IRON RIDGE SUBDIVISION FILING NO. 1 & 2

FINAL DRAINAGE REPORT

PCD FILE NO: SF2612 & SF2613
ALL TERRAIN ENGINEERING PROJECT NO: 25009
JUNE 2026

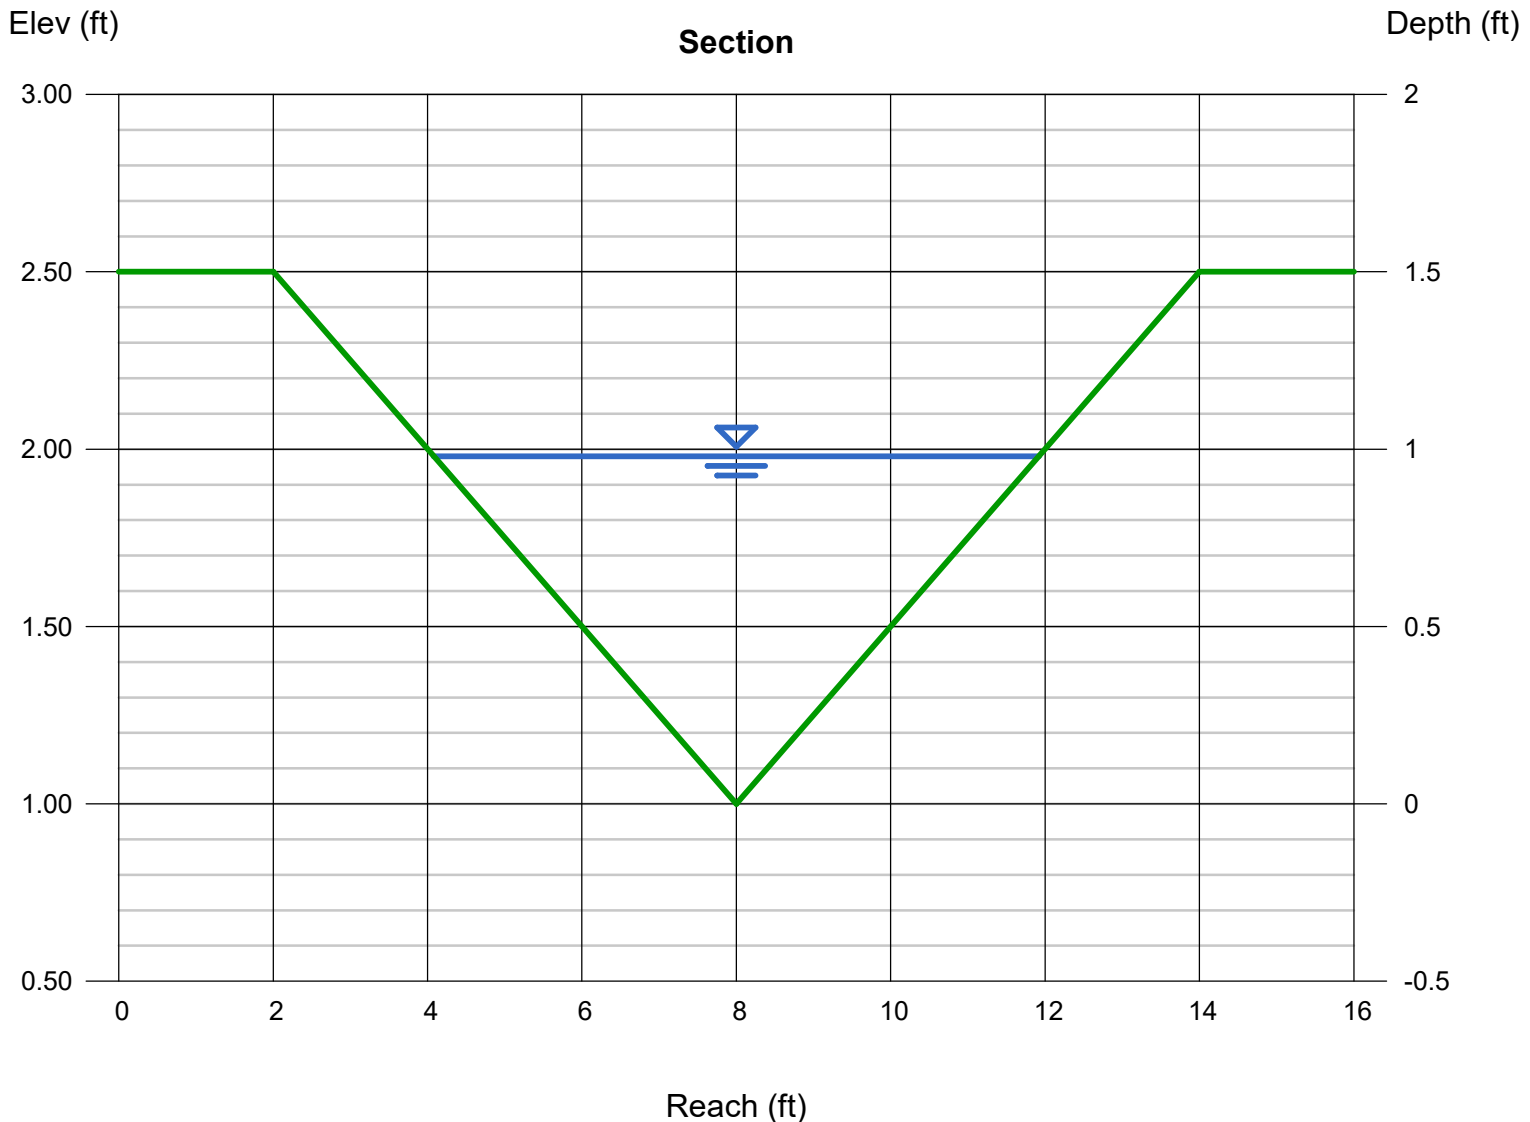
Is this supposed to be DP1 Swale (Q100)? All of the input values match the Channel Report for DP1 Swale (Q100). Please review and revise as necessary.

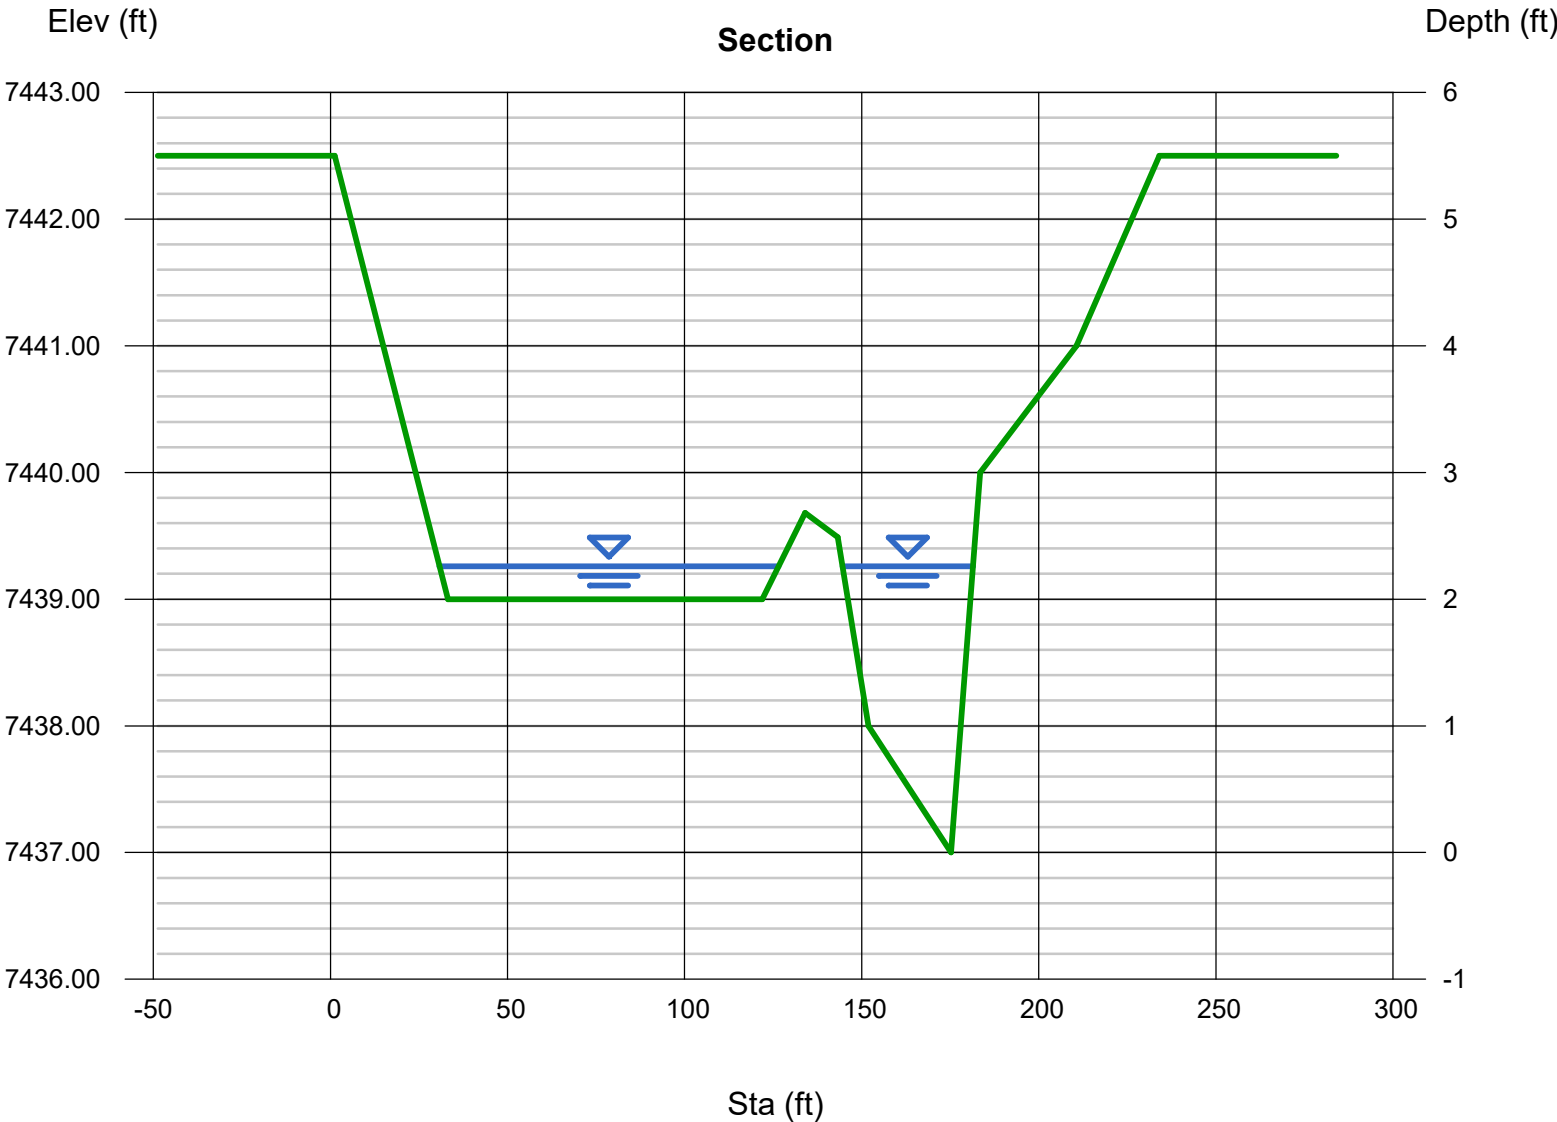
Q₁₀₀ = 287.7 cfs at DP15 per
Appendix B calculations.
Please revise.

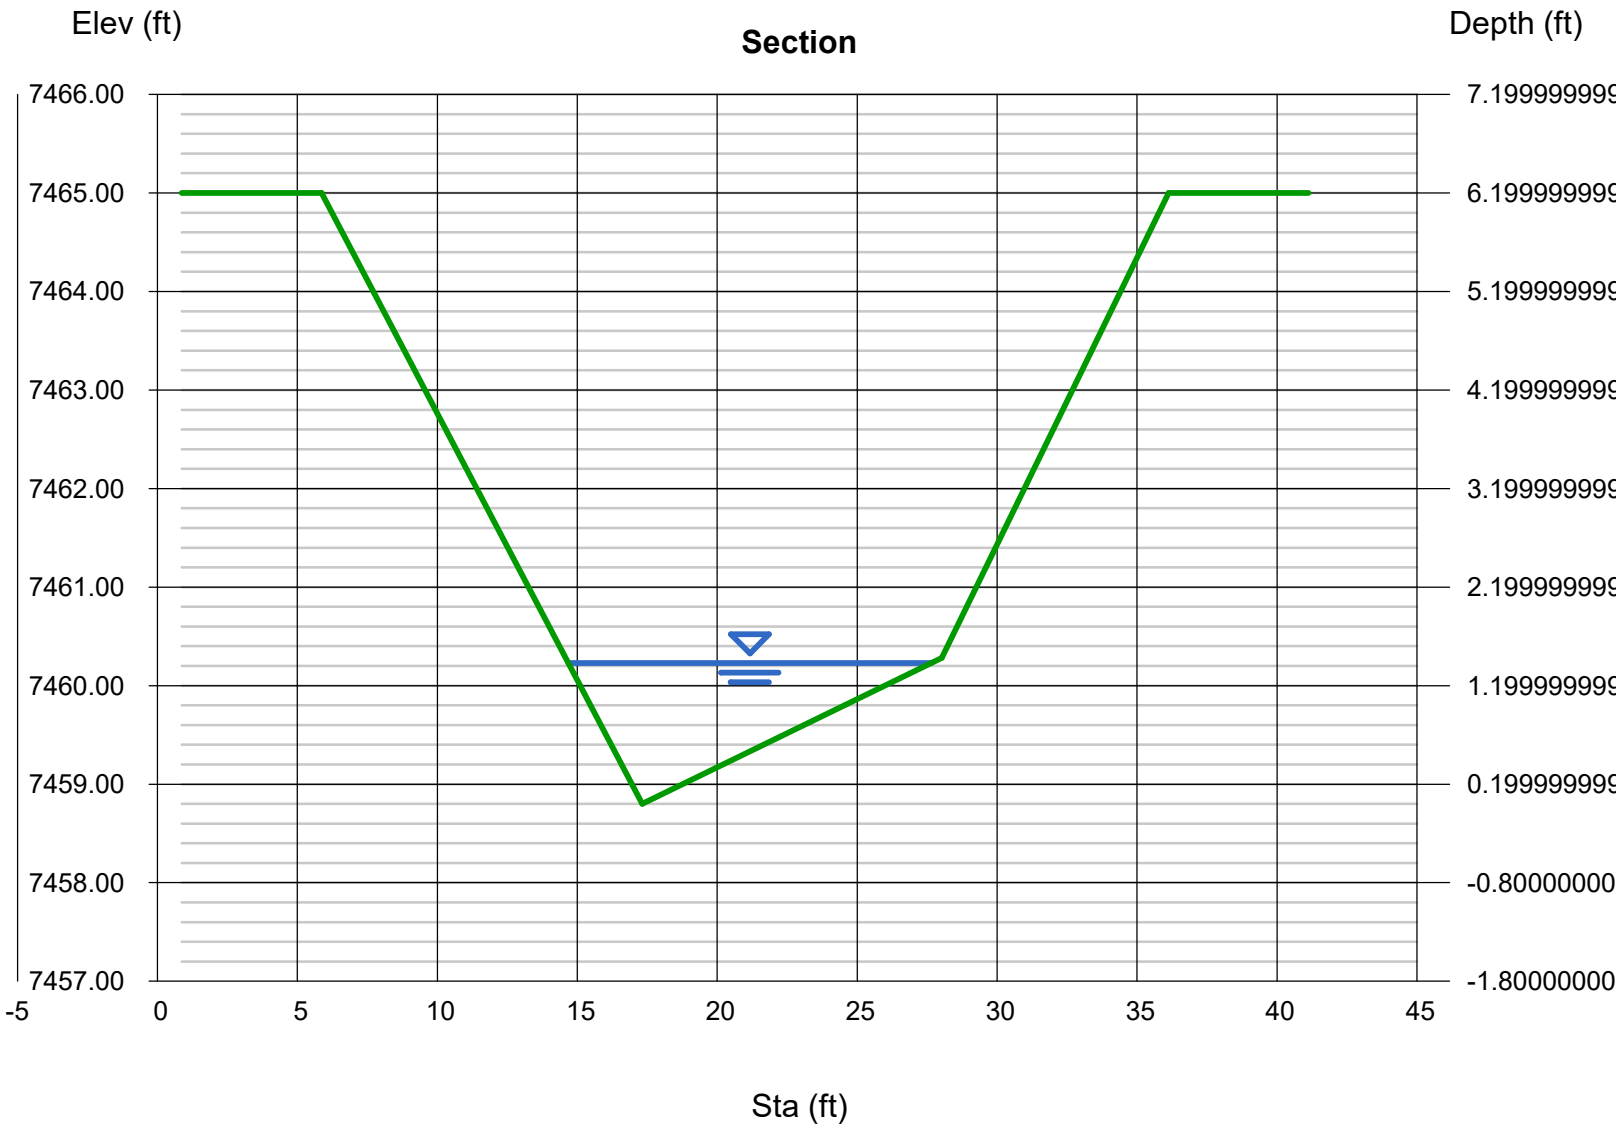
Q₁₀₀ = 40.8 cfs at DP 11 per
Appendix B calculations.
Please revise.
